**OLYMPIA DESIGN REVIEW BOARD
RECOMMENDATION**

PROJECT NAME: Intercity Transit, Pattison Site Expansion Phase II

PROJECT No.: 19-1636

**CONCEPT DESIGN REVIEW
STAFF REPORT
June 27, 2019**

STANTEC ARCHITECTURE
1050 17TH STREET, SUITE A200
DENVER, CO 80245

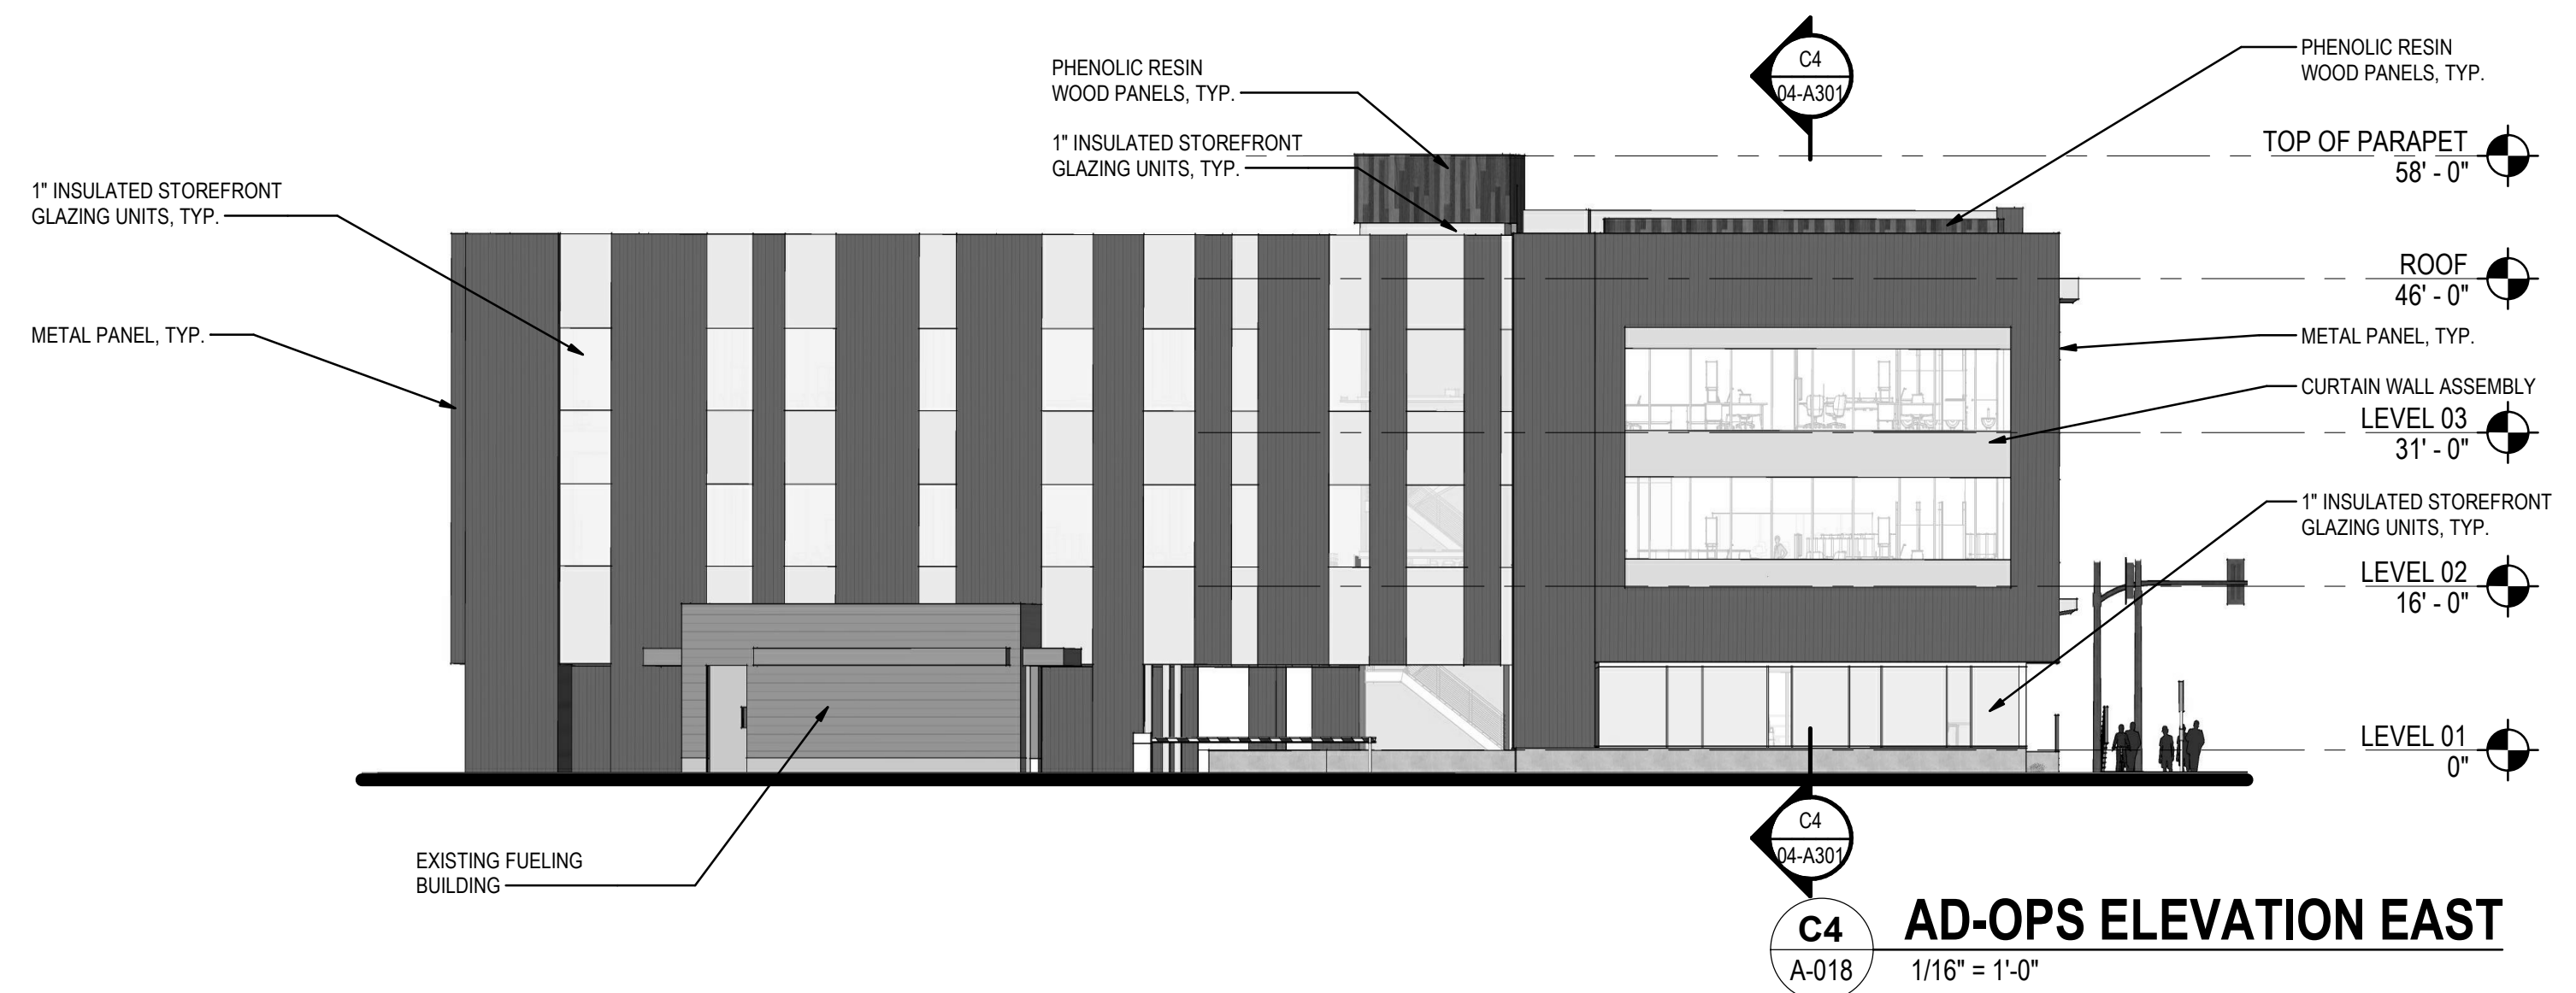
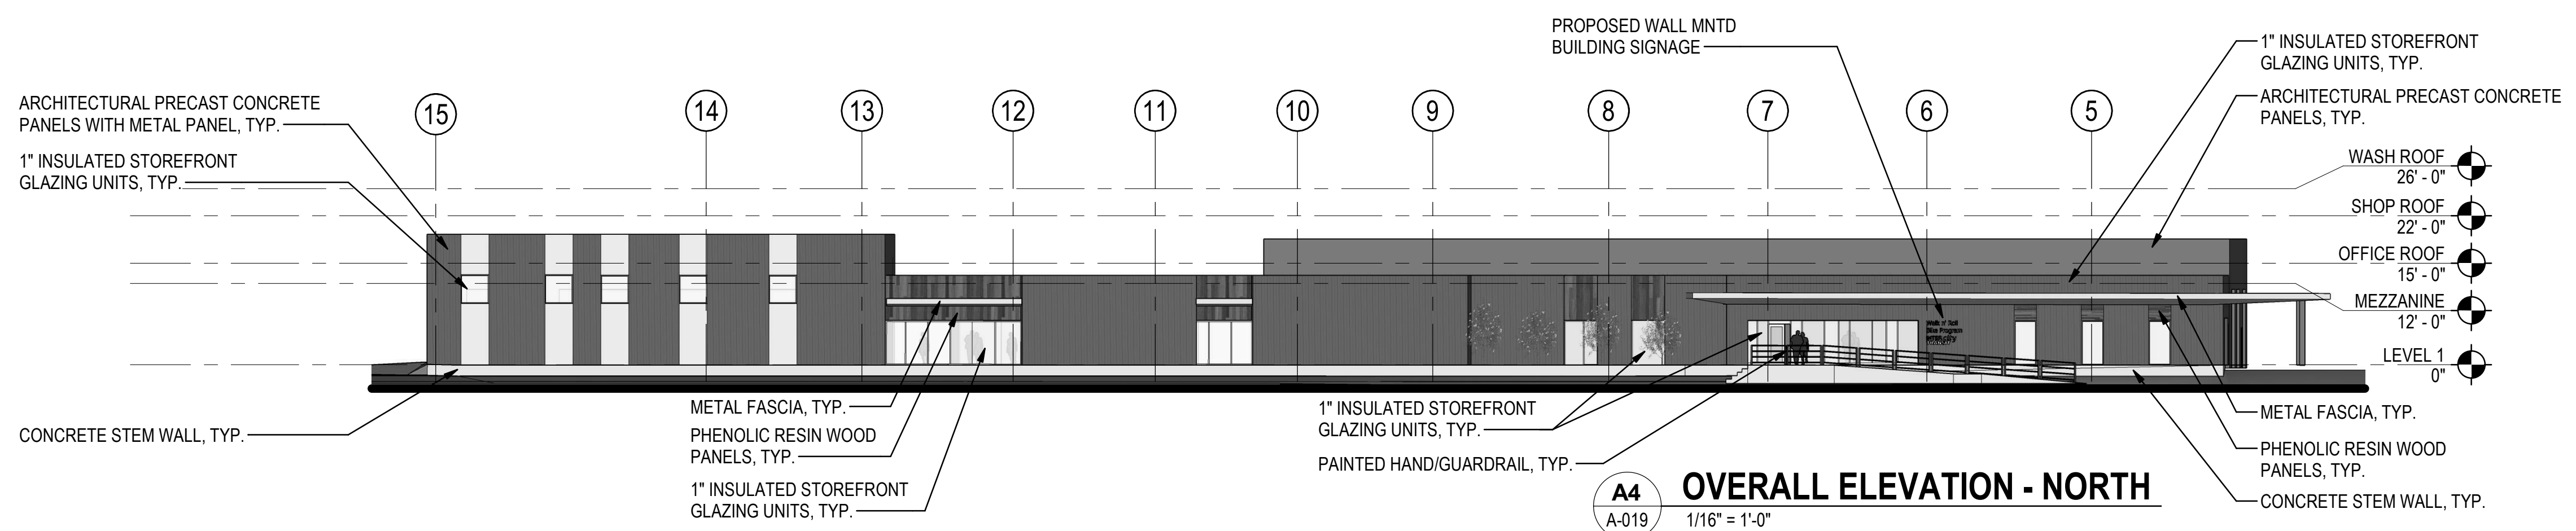
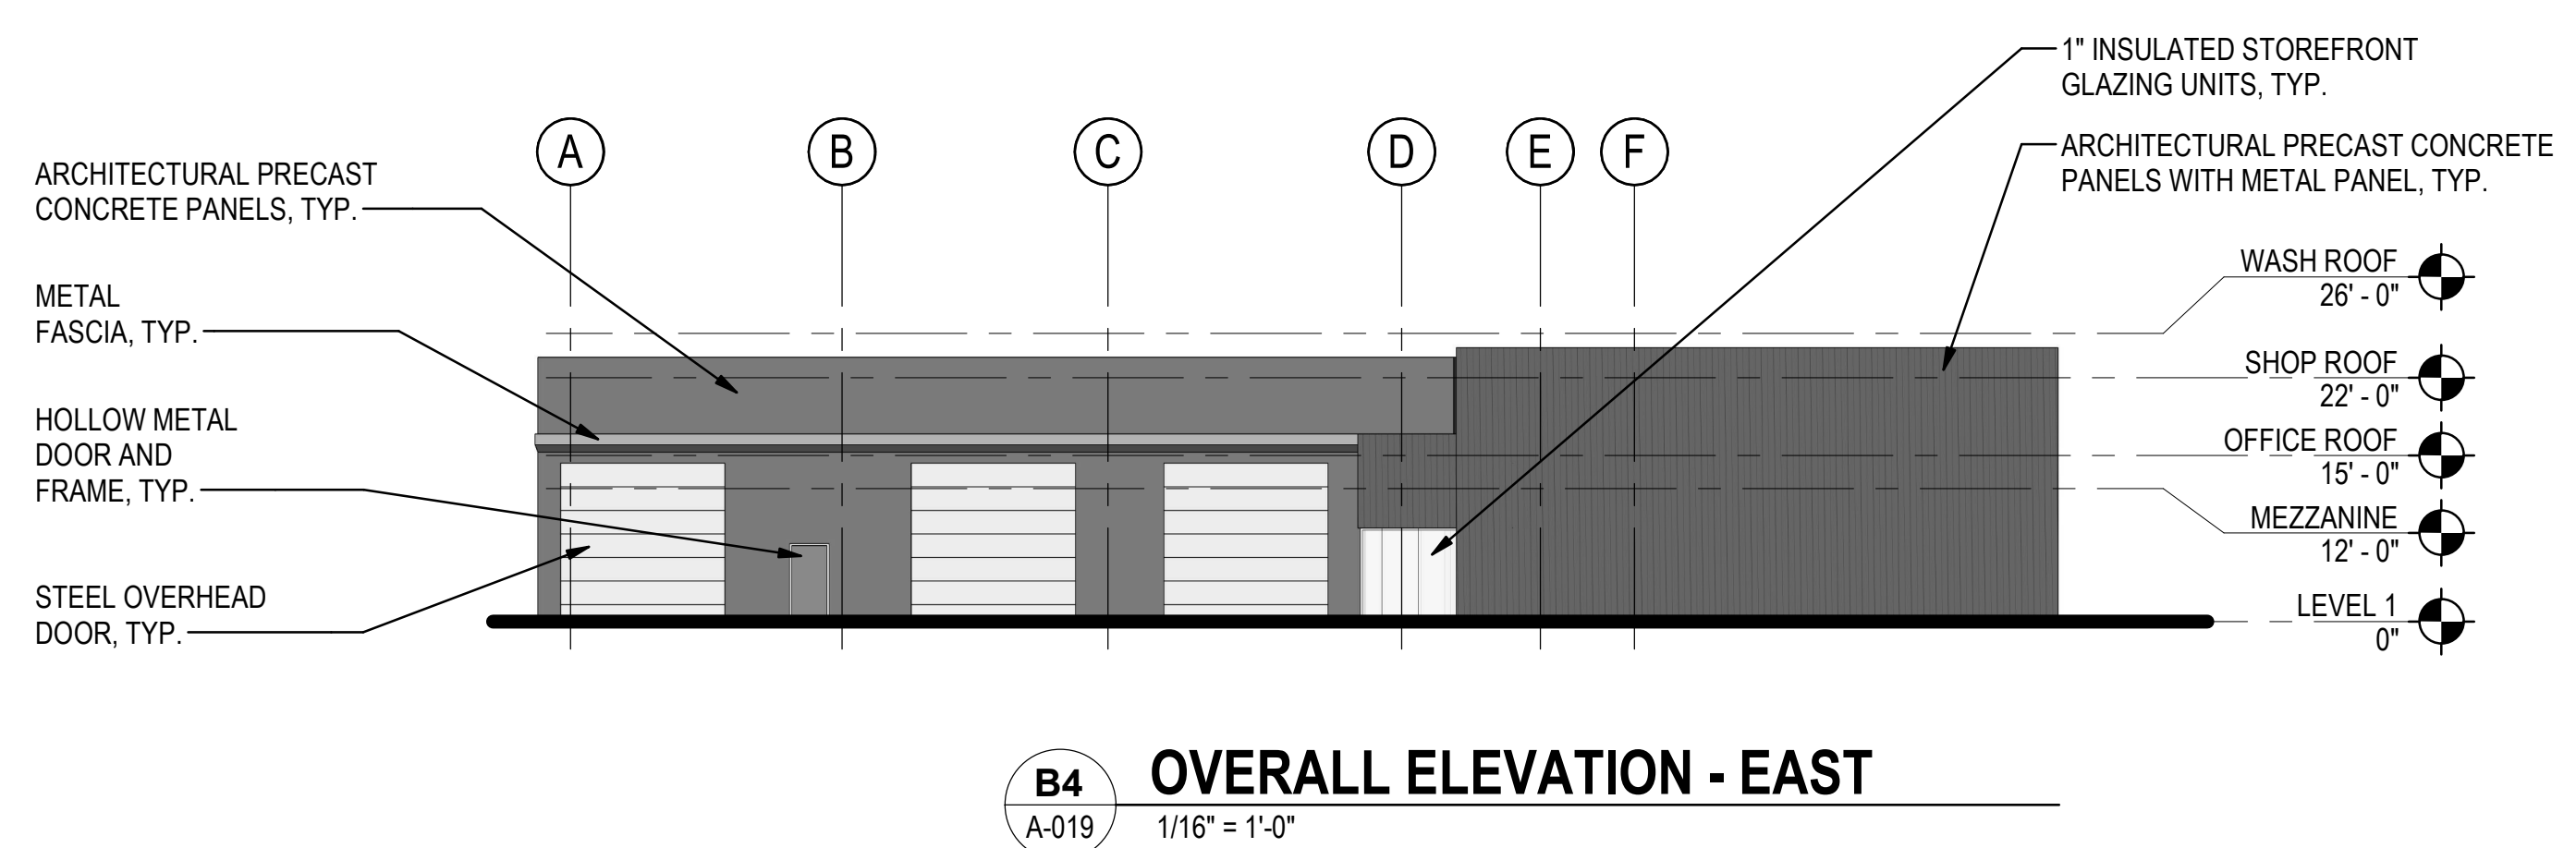
A minimum of 60 percent of the street façade between two and eight feet in height must be screened when placed on a street frontage. The parking proposed in the administration building is directly adjacent to Pattison Street and must comply with this standard. Plans do not show the requisite screening. The code establishes several ways in which to obtain compliance such as decorative metal grille work, artistic detailing, vertical trellises, and landscaping. The landscaping plan indicates several trees, shrubs and ground covers will be installed in the landscaping area between the sidewalk and the street, however it is not clear if this landscaping alone will adequately provide screening. Additionally, all surface parking facing a street must be screened with landscaping, berms or low walls. It is unclear if surface parking areas will be adequately screened.

The code requires for long expanses of blank walls or fences to be screened. The fencing along Martin Way between the buildings and the fencing behind the administrative structure separating the public and employee only area appear to be long expanses of fencing/walls. The elevations do not show screening, but the landscaping plan shows a series of trees and shrubs in these locations. It is likely that these plantings will adequately screen the long expanses of fencing, however in some areas it is somewhat unclear if plantings are proposed on the inside or outside of the fencing. For example, the landscaping plan shows a fenced employee area along Martin Way associated with the fuel, wash, and facilities building that includes vegetation on the inside, but not outside of the fence. This area is not easily identifiable from the elevation plans, but can be seen on the landscaping plan. Elevation plans that show landscaping would help show the effect the proposed landscaping has on the long expanses of fencing and other portions of the building. This is necessary to determine if the landscaping adequately screens these long expanses of fences.

The code requires all walls visible to pedestrians that are over 30 ft. in length to be modulated and building elements to be articulated. The façade along the administrative building comply, but there are some areas along the façade of the fuel, wash, and facilities building that are 45 ft. in length without modulation. Plans should be revised to comply.

Staff Response for Conceptual Review: At grade vehicular parking is proposed along Pattison Street. The elevation plan does not show the type of screening, artwork, or other features intended to meet this requirement. The landscaping plan shows plantings and street trees along this frontage that will provide some screening.

Staff Response for Conceptual Review: The code asks for long expanses of blank walls or fences to be screened. The fencing along Martin Way between the buildings and the fencing behind the administrative structure separating the public and employee only area appear to be long expanses of fencing/walls. The elevations do not show screening, but the landscaping plan shows a series of trees and shrubs in these locations. It is likely that these plantings will adequately screen the long expanses of fencing, however in some areas it is somewhat unclear if plantings are proposed on the inside or outside of the fencing. For example, the landscaping plan shows a fenced employee area in along Martin Way

associated with the fuel, wash, and facilities building that includes vegetation on the inside, but not outside of the fence. This area is not easily identifiable from the elevation plans, but can be seen on the landscaping plan. Elevation plans that show landscaping would help show the effect the proposed landscaping has on the long expanses of fencing and other portions of the building. This is necessary to determine if the landscaping adequately screens these long expanses of fences.

Staff Response for Conceptual Review: There is one section of the facilities building that includes a wall of approximately 46 ft. in length without modulation or other building elements and the fencing between the two buildings spans 75 ft. without modulation. The 30 ft. length is a requirement, therefore plans will need to be revised to comply.

Staff Response for Conceptual Review: The visitor parking is located under the building at ground level along the frontage of Pattison Street. It has been strategically located to tuck in behind the building frontage and prominent intersection of Pattison Street and Martin Way. It is unclear if the street level surface parking will be adequately screened. The landscaping plan shows several trees and shrubs directly in between the sidewalk and the parking lot, but metal work or other features that would allow climbing plants has not been identified.

Proposed Condition of Approval: The applicant shall revise the elevation plans to show proposed screening devices and plantings to ensure 60 percent coverage between two and eight feet in height along the wall.

Condition of approval: Show landscaping and other site features that are intended to be greater than 30 in. above grade in the elevation plans with Detail Design Review.

Condition of Approval: Revise plans to ensure walls are modulated at intervals of no less than 30 ft. where visible from pedestrians.

Condition of Approval: Show the proposed features that will provide texture and screening to the surface level parking. Use artwork, metal grille work or similar detailing that provides texture and covers the parking structure openings.

Condition of approval: Show landscaping and other site features that are intended to be greater than 30 in. above grade in the elevation plans with Detail Design Review.

Condition of Approval: Revise plans to ensure walls are modulated at intervals of no less than 30 ft. where visible from pedestrians.

Condition of Approval: Show how screening of the surface level parking below the building on the Pattison Street frontage is being provided.
